# CITY OF ALBUQUERQUE

#### RE: 5400 Sevilla NW Grading Plan Engineer's Stamp Date: 10/23/17 Drainage File: F11D010A

Based on the information provided in your submittal received 10/23/17, the Grading Plan cannot be approved until the following are addressed:

ENGINEER'S SEAL	VISTAS DE LA LUZ	DRAWN <sup>BY</sup> <sub>WCWJ</sub>
ANID SOL	COMMERCIAL	DATE 9-05-17
REGISTER AND	GRADING AND DRAINAGE PLAN	21644-LAYOUT-1-06-17
18 APOFESSION NLE	Rio Grande	SHEET #
10/23/17	Engineering	
DAVID SOULE P.E. #14522	SUITE 201 ALBUQUERQUE, NM 87106 (505) 872–0999	JOB

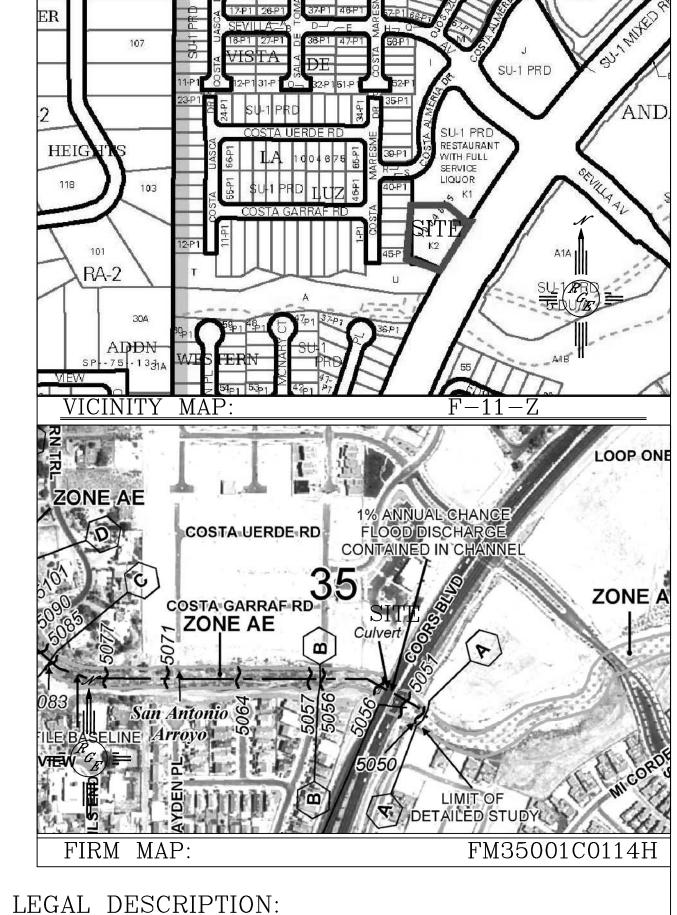
- 1. Clearly define and quantify the areas of new paving vs. re-paving. If the repaving is actually mill and overlay state so.
- Albuquerque 2. Quantify the first flush requirement based on the newly paved and repaved area.
  - 3. A drainage basin exhibit is required. This will need to show which areas drain to which ponds.
  - 4. The ponds need to be located where they can effectively capture the first flush requirement from impervious surfaces of the lot.

5. If the first flush volume cannot be captured on-site, the bypass volume must be quantified for payment of Fee-in-Lieu.

- 6. A Bernalillo County Recorded Private Facility Drainage Covenant is required for the stormwater quality ponds. The original notarized forms, exhibits, and recording fee (\$25, payable to City of Albuquerque) must be turned into DRC (4th, Plaza del Sol) for routing. Please contact Charlotte LaBadie (clabadie@cabq.gov, 924-3996) or Madeline Carruthers (mtafoya@cabq.gov, 924-3997) regarding the routing and recording process for covenants.
- 7. Payment of the Fee in Lieu (Amount = CF of BypassFlow x \$8/CF) for any first flush volume not captured must be made.

The request for Building Permit appears unnecessary as there do not appear to be any new buildings associated with this request. If you have any questions, please contact me at 924-3695 or dpeterson@cabq.gov.
